Chapter 1

Items 1-1-12 through 1-10-12

June 14, 2013.

This is one of ten documents containing those proposed changes to the A117.1 Standard, 2009 edition; for which Committee Ballot comments or Proponent Comments were received. Each item will be discussed at the meeting of A117.1 Committee during the week of July 15, 2013, in Washington D.C. This document does not contain proposals for which no comments were received. Those proposals, and the Committee decision on each one, can be viewed in the Committee Action Report (CAR) under the title: First Draft Standard Development at this following location: <http://www.iccsafe.org/cs/standards/A117/Pages/default.aspx>

**Figure 304.3(a)
SIZE OF TURNING SPACE**

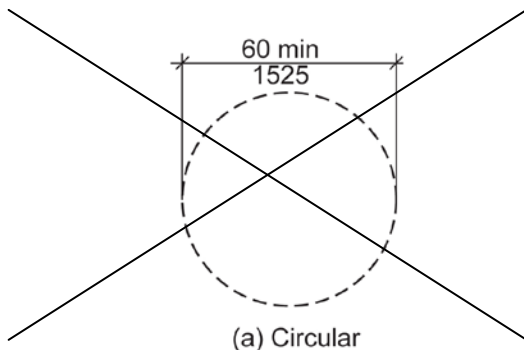
304.3.1 Circular Space. The turning space shall be a circular space with a ~~60-inch~~ 67-inch (4525 1700 mm) minimum diameter. The turning space shall be permitted to include knee and toe clearance complying with Section 306.3.

FIG. 306.2
TOE CLEARANCE

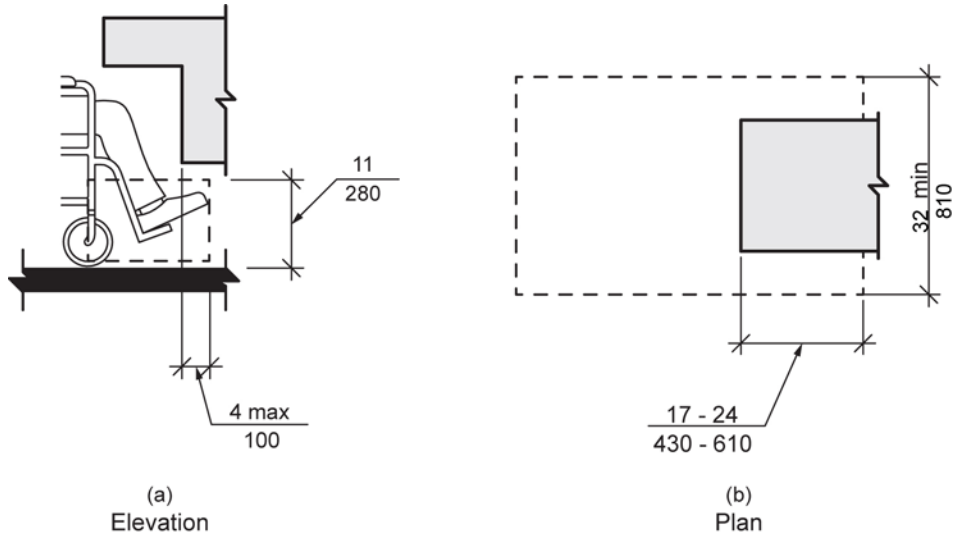
NOTE: This change necessitates a change to Fig. 306.2 and Fig. 306.3 to ensure consistency. Thus, the proposed revised figures have been attached, along with the existing figures for comparison purposes.

FIG. 306.3
KNEE CLEARANCE

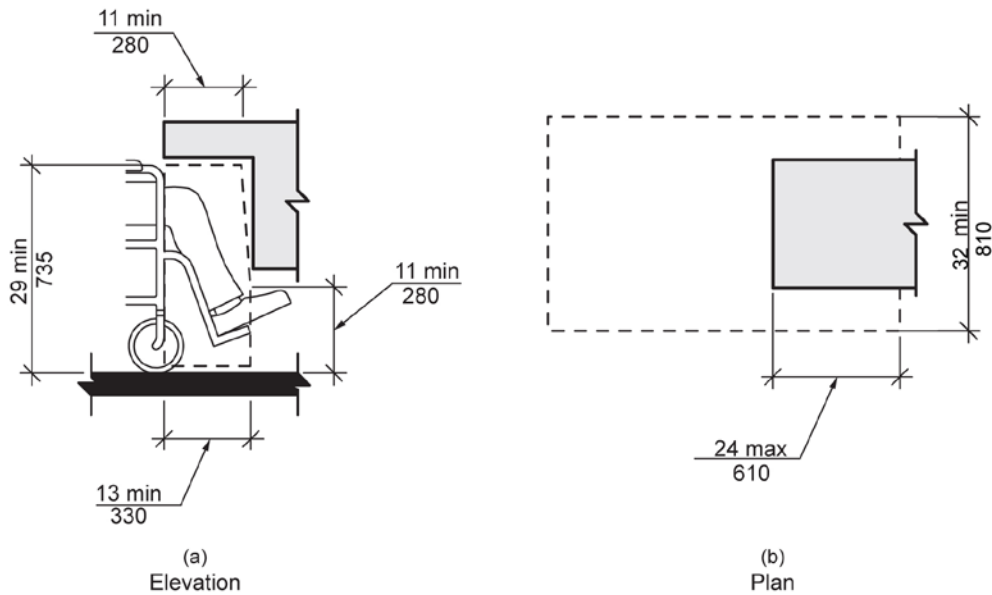
306.3.4 Clearance Reduction. Between ~~9~~ 11 inches (~~230~~ 280 mm) and ~~27~~ 29 inches (~~685~~ 735 mm) above the floor, the knee clearance shall be permitted to be reduced at a rate of 1 inch (25 mm) in depth for each ~~6~~ 9 inches (~~150~~ 230 mm) in height.

306.3.5 Width. Knee clearance shall be ~~30~~ 32 inches (~~760~~ 810 mm) minimum in width.

FIG. 308.3.1
UNOBSTRUCTED SIDE REACH

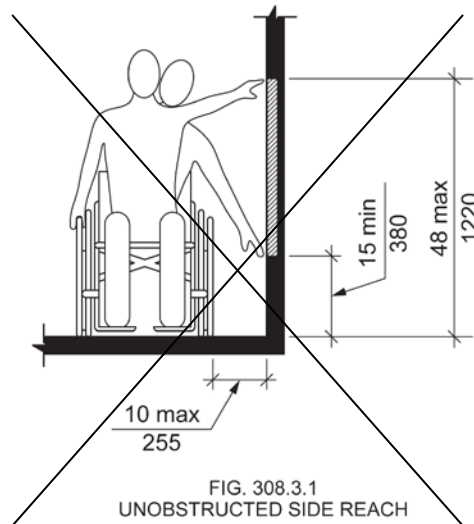
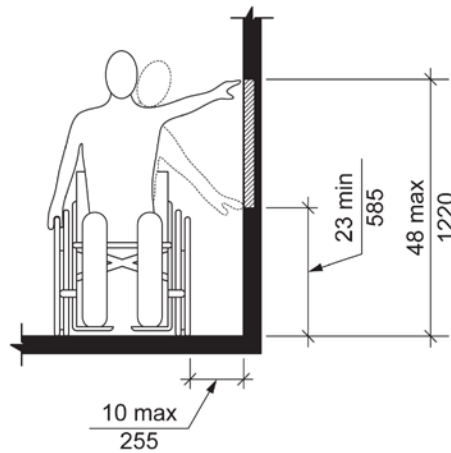
NOTE 2: This change necessitates a revision to Fig. 308.3.1 to ensure consistency. A revised figure is attached.

**Fig. 308.3.1
Unobstructed Side Reach**

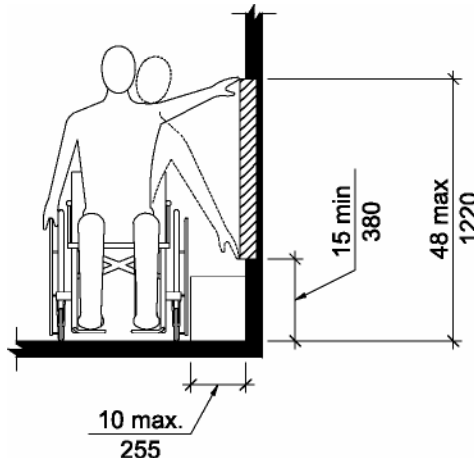
Reason: Forty eight inches is too low for people not in wheel chairs. This would match UFAS 4.2.6.

The following is Figure 404.2.3.2(e) from the A117.1-2009 standard.

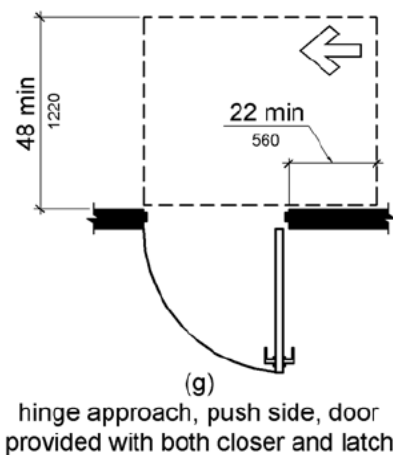
Because this extra requirement creates a discrepancy between the A117.1 and ADA which is not readily apparent and well known, the elimination of the footnote reference would help to coordinate the two standards and make this basic issue of door maneuvering clearances consistent. It seems that the addition of this requirement was probably not well justified when it was added into the 2003 A117.1 standard and with the change made in Section 404.2.3 of the 2009 edition which prevented door maneuvering clearances from including knee and toe clearance it made the difference between the A117.1 and the federal requirements that much greater. With some of the task groups looking at changing the 'building blocks' which could further affect maneuvering

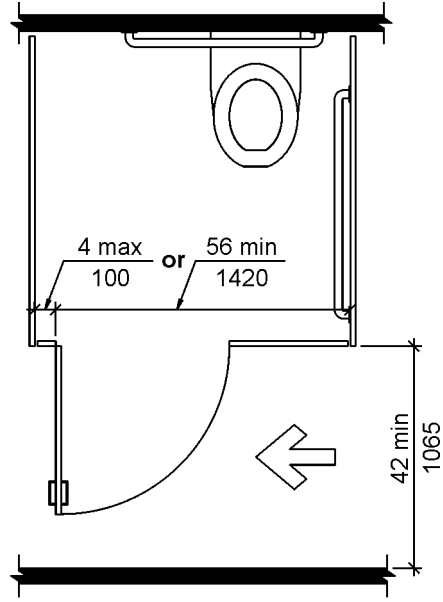
Change the called dimension for door opening location to read: 4 inches (100 mm) minimum to 6 inches (150mm) maximum).

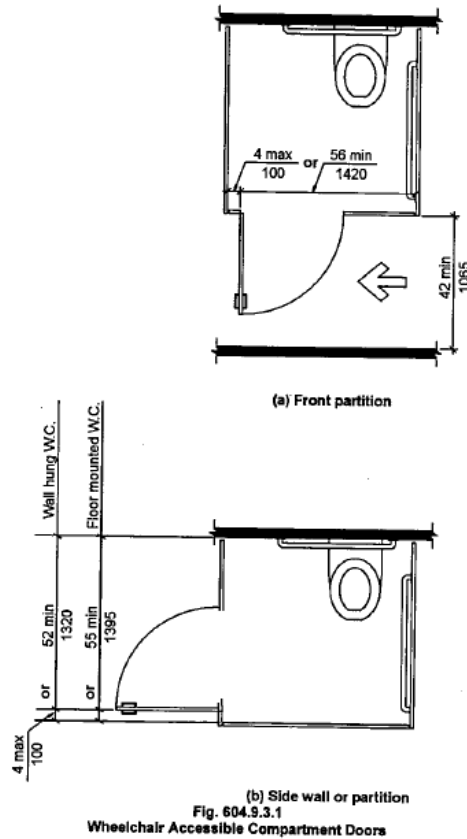
Change the called dimension for door opening location to read: 4 inches (100mm) minimum to 6 inches (150mm) maximum.

FIG. 607.2(b)
CLEARANCE FOR BATHTUBS

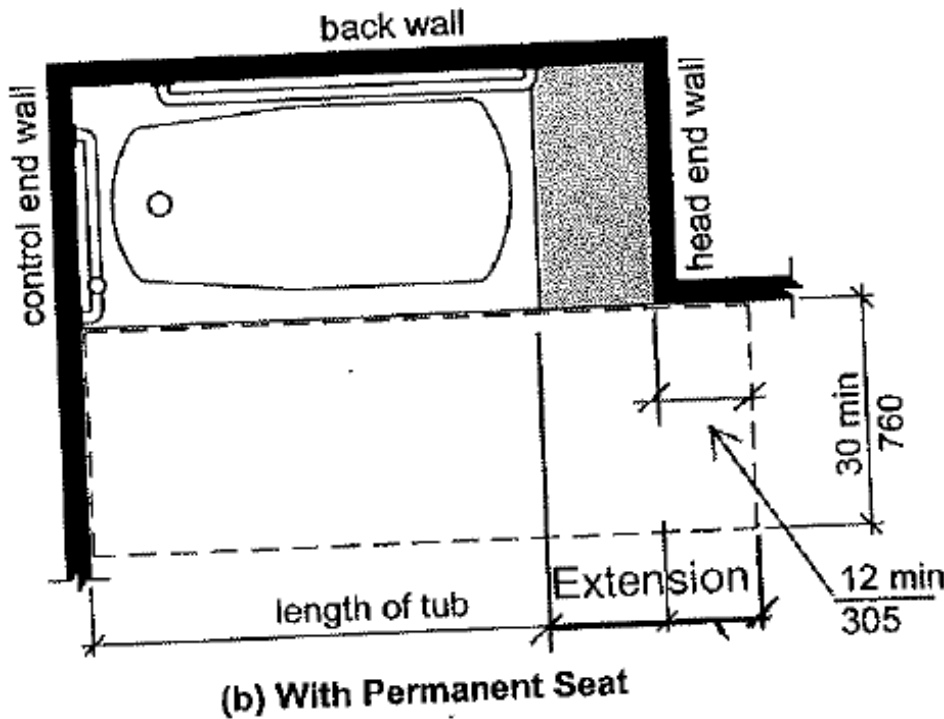
Section 607.4.1 sets the 'depth' of the seat. The current language skips the piece between the 'length of the tub' and the end of the extension. This is a technical issue that just gives you all the pieces. Please see graphic revision attached.
